Revision since issued on 12.09.26:

Project Title:
South Tyneside College - Listed Building

Drawing Title:
External Door Schedules inc Ironmongery

Draw No: CAS015-GSSA-LB-XX-DR-A-3115
Rev: C06

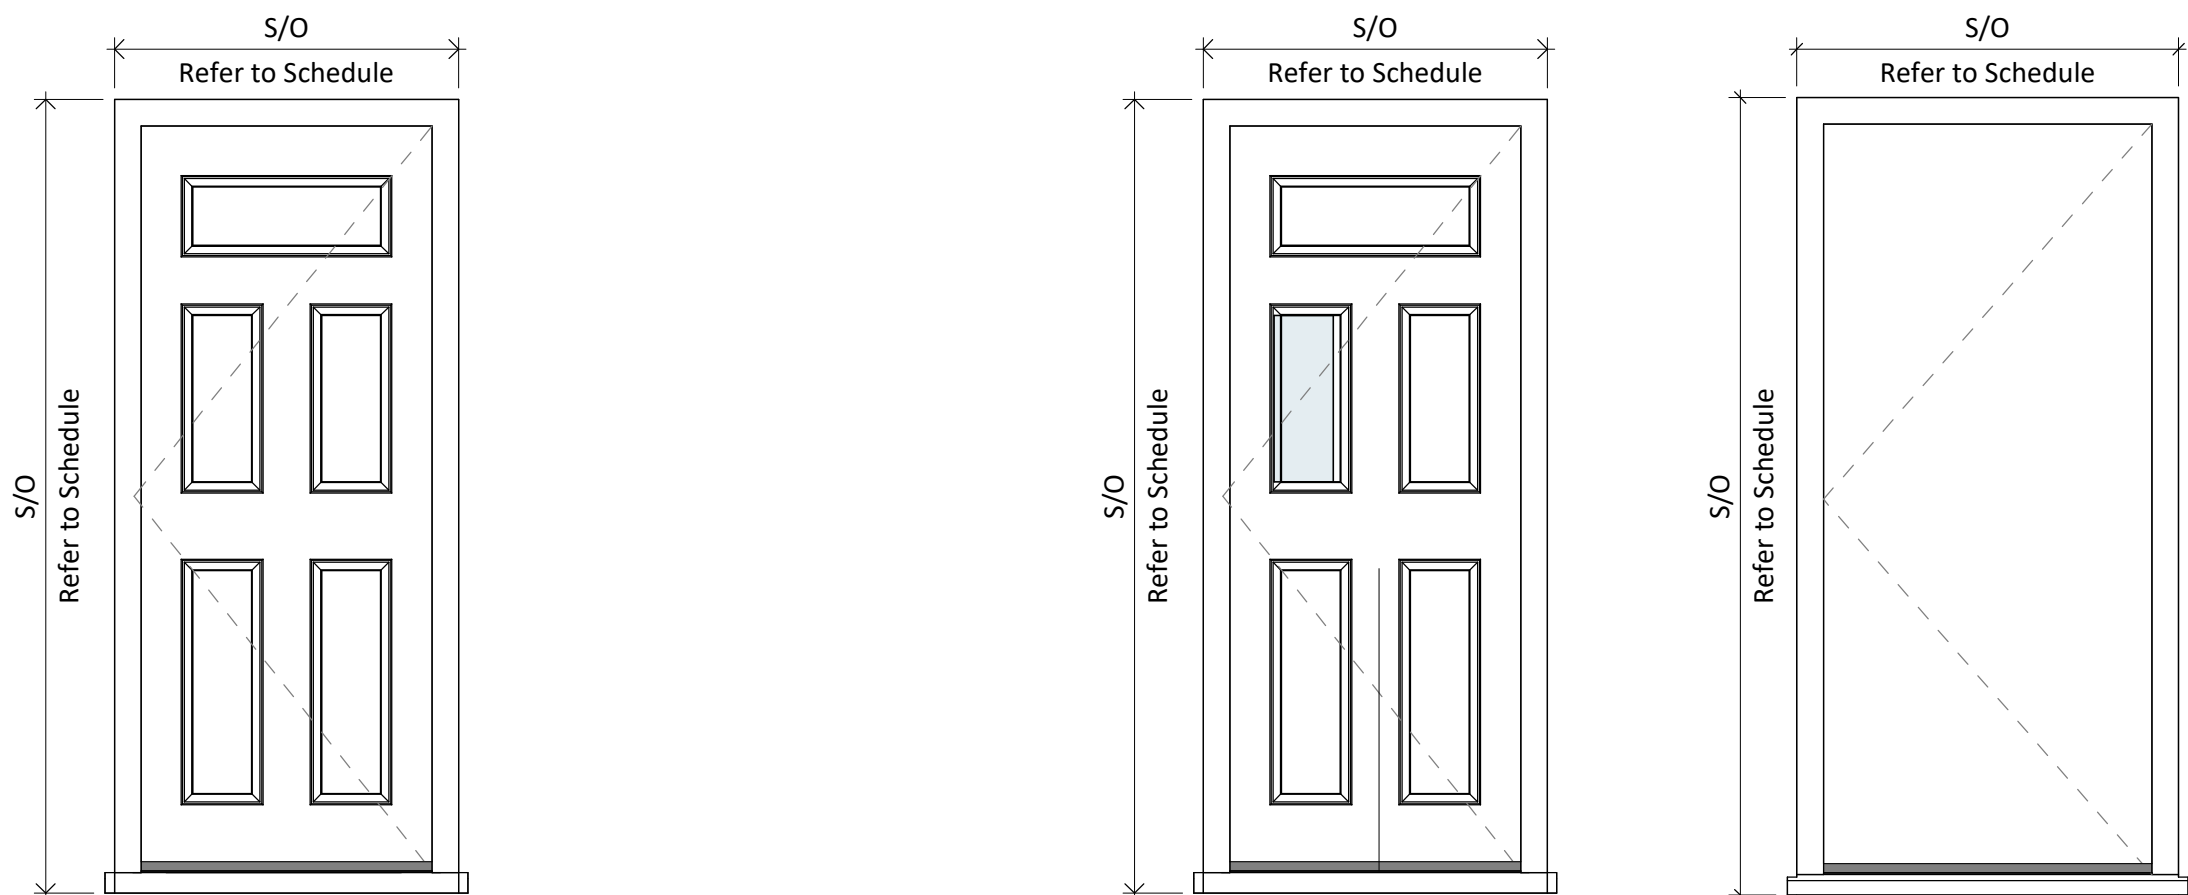
- External door elevations added alongside the corresponding door types within the door schedule.
- EDB.05; ED0.05, ED1.04 and ED2.03 door elevation revised to a five-panel door design.
